# UNITED STATES PATENT AND TRADEMARK OFFICE

## Office Action Summary

10/544,192

**DETAILED ACTION**

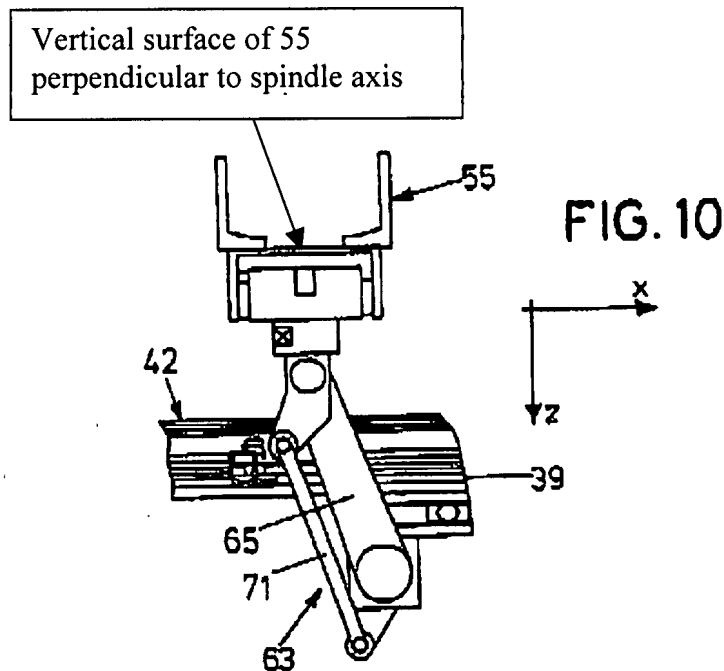
Re claim 2, see Figures 4 and 14, noting that the “pallet support member” including, for example, at least element 55, is movable along the track or conveyor path 38 in a horizontal direction perpendicular to the horizontal spindle axis (see also Figure 1, noting the configuration and location of path 38 relative to the horizontal spindle axis) to positions such that it is “arranged in the extension of said table or said pallet mount in the horizontal direction perpendicular to the spindle axis” as claimed.

Additionally, re claim 2, note that the “pallet support member” including, for example, at least element 55, on a side (such as the right side as viewed in Figures 1, 9, and the top side as viewed in Figures 10-12, noting the orientation of 38/39 shown in Figures 9-12) of the pallet support member (55 would be located at the left of Figure 1) where the pallet 31 moves when it is held by 29 (see Figure 1), is able to be arranged “in parallel” to a pallet mounting surface of the table/pallet mount 26/29 (see Figures 1 and 9-14, for example).

Also, re the new language in claim 2, note that the “table” or “pallet mount” 26/26 has surfaces (at least the vertical left and right surfaces as viewed in Figure 1) that extend perpendicularly to the horizontal spindle Z axis (see Figure 1). Note also that the “pallet support member” including at least element 55 is movable to a position in the horizontal direction perpendicular to the spindle axis (along path 38, for example, as shown in Figure 4) such that it can be considered to be “arranged” in an extension (see Figure 1, noting that the path 38 is ultimately connected to/ultimately extends from the table/pallet mount 26/29) of the table/pallet-mount 26/29).

Furthermore, note that the “pallet support member” (including at least element 55) includes a vertical surface that is arranged such that it is capable of contacting a pallet surface

and that is arranged in parallel to the “pallet mounting surface” of the “pallet mount” 26/29 that is perpendicular to the spindle axis as labeled below in Figure 10 (noting that Figure 10 is a top view).

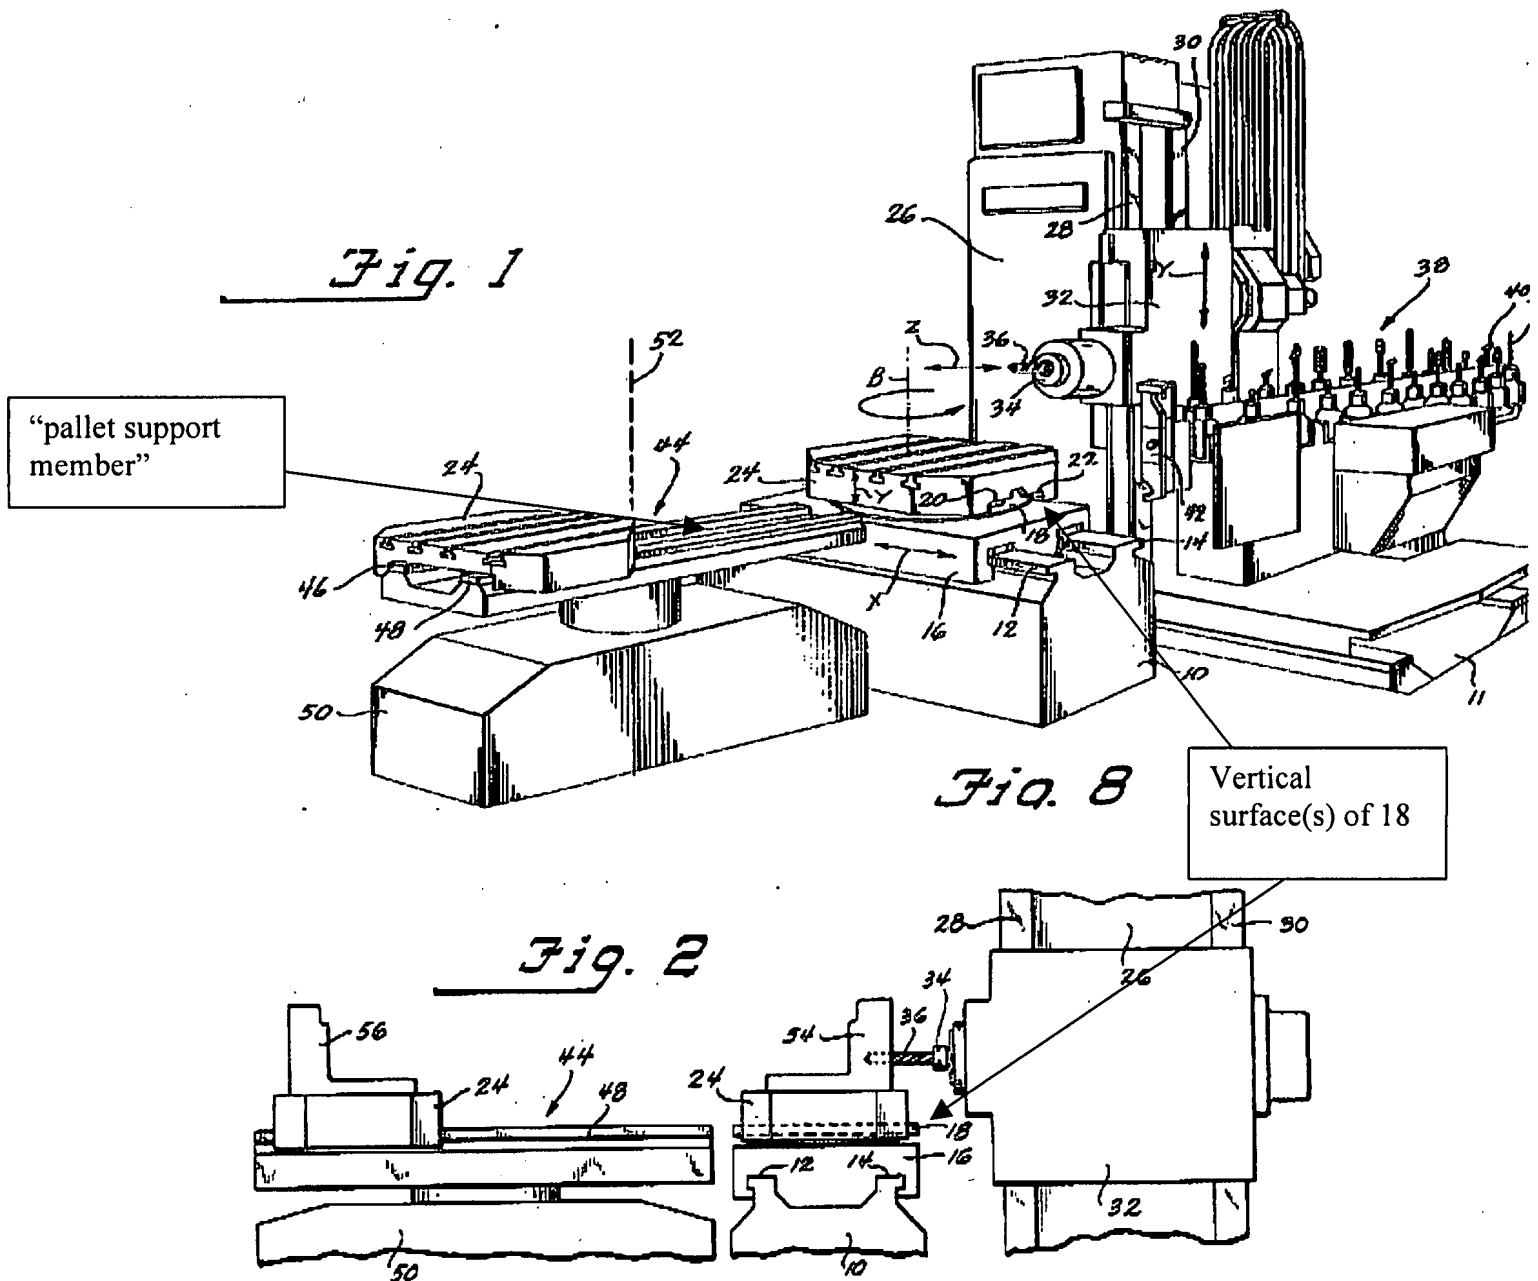
6. Claim 1 is rejected under 35 U.S.C. 102(b) as being anticipated by U.S. Pat. No. 4,090,287 to Selander, for example.

Note that tool 36 is rotated by a tool spindle about a horizontal axis, and that a pallet exchanging device 44 (Figures 1-2) for exchanging pallets 24 has a “pallet support member” (labeled below) that is rotatable about a vertical axis 52 (Figure 1). Also note that the “pallet

support member" has at least two vertical "pallet mounting surfaces (vertical sides of the ways 46, 48 of the pallet support member) on which the pallets 24 are removably mounted.

Re the new language in claim 1, it is noted that the pallet support member vertical surfaces previously described can each have a "distinct pallet" removably mounted thereon,

noting that a first distinct pallet is shown at the left of the pallet support member Figure 1, and a second distinct pallet is generally mounted at the other end of the pallet support member (the pallet that is shown on the member 16 in Figure 1, but that is explicitly shown on the pallet support member in at least Figures 2-4).

Table” or “pallet mount” 18 has a vertical surface that faces the spindle and that is perpendicular to the axis of the spindle, and when the table or pallet mount 18 is rotated about vertical axis B to the position shown in Figure 1, has a vertical surface perpendicular to the axis of the spindle on which the pallet 24 is “mounted”, as broadly claimed (see Figure 1 especially, see the reproduction of Figures 1-2 above).
